UNITED STATES  
NUCLEAR REGULATORY COMMISSION  
WASHINGTON, D. C. 20555

MAR 12 1987

SUBJECT: REQUEST FOR ADDITIONAL INFORMATION-ASSESSMENT OF LICENSEE MEASURES  
TO MITIGATE AND/OR IDENTIFY POTENTIAL DEGRADATION OF MARK I DRYWELLS  
(GENERIC LETTER 87-05)

Figure 1

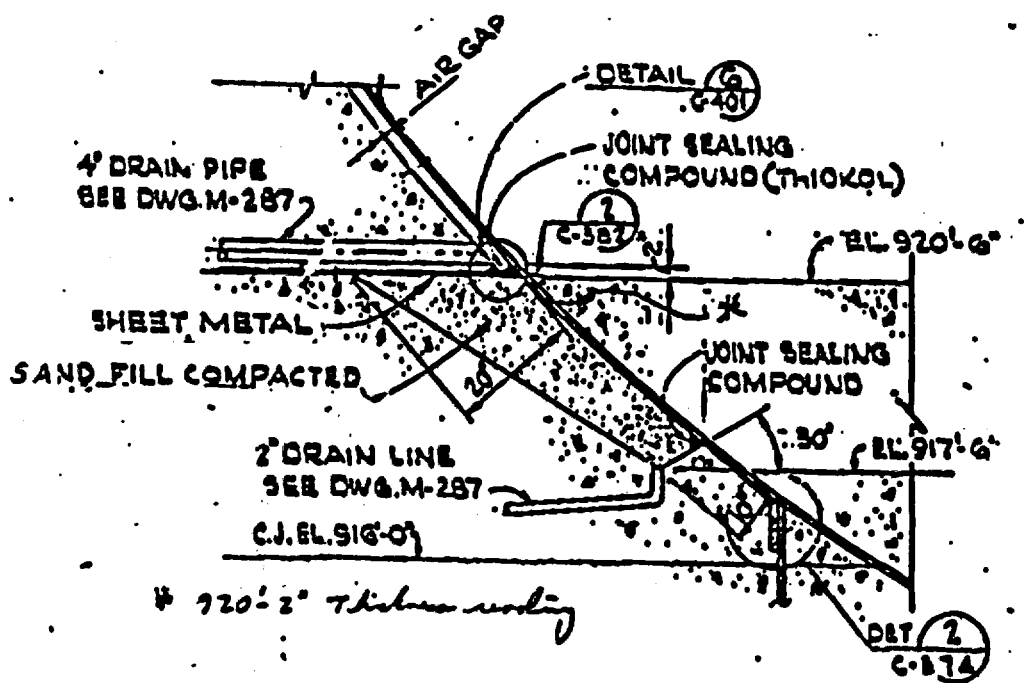
From the information obtained from the review of the Oyster Creek event, it appears one source of leakage that resulted in wetting the sand cushion was related to the deterioration of a drain line gasket at the drywell to cavity seal (see figure 1). There also is some question as to whether or not the drain line which serves to remove any leakage past the drywell to cavity seal was functioning properly.

- 1) Provide a discussion of your current program and any future plans for determining if the drain lines that were provided at your facility for removing any leakage that may result from refueling or from spillage of water into the gap between the drywell and the surrounding concrete or from the sand cushion itself are unplugged and functioning as designed.

- 2) Provide a discussion of preventive maintenance and inspection activities that are currently performed or are planned to minimize the possibility of leakage from the refueling cavity past the various seals and gaskets that might be present.
- 3) Confirm the information listed in Table 1 is correct with regard to your facility.

Figure 2

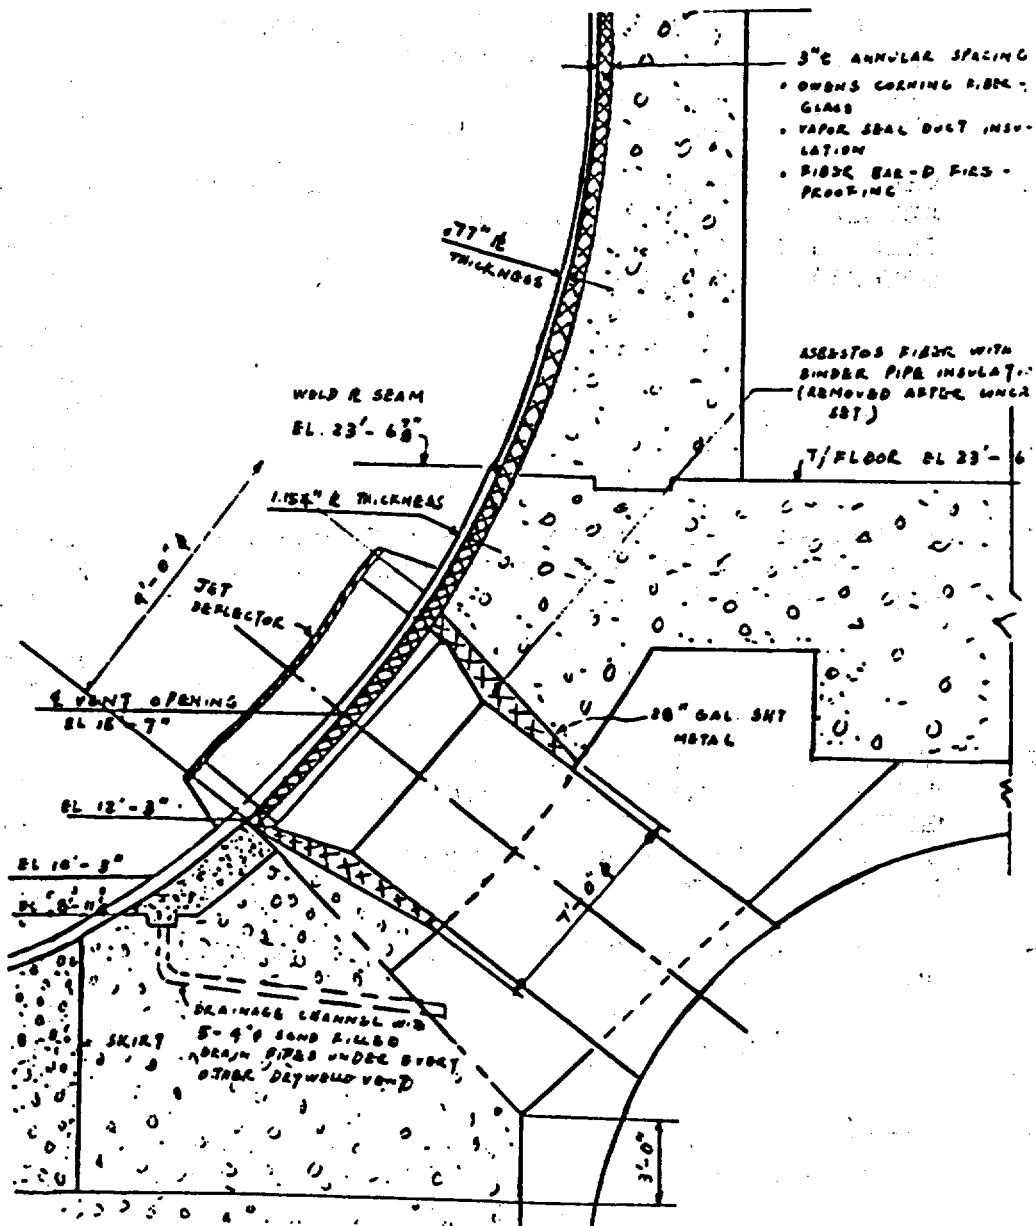
Upon reviewing the details of the sand cushion design at the various Mark I facilities, there appears to be a design feature that varies, dependent on the architect-engineer, that may be significant. In some designs, Figure 2, the sand cushion is covered with a galvanized steel plate which is sealed to the drywell shell and the surrounding concrete. Further, drains are provided to remove water which might collect on the plate from above. In other designs, Figure 3, the sand cushion is open to the gap between the drywell shell and the surrounding concrete and the only path for water to drain from the sand cushion is through the small drain lines at the bottom of the sand cushion. It appears from the Oyster Creek experience that, with the high permeability of the sand cushion and the small bottom drains, the likelihood of adequately drying the sand cushion is low if copious amounts of water have entered the sand cushion. The staff has sufficient concern to initiate the collection of information of the licensee's current or proposed action to assure the degradation of the drywell shell plates adjacent to the sand cushion has not occurred and to determine if augmented inspections above and beyond those planned by the licensee's are necessary.
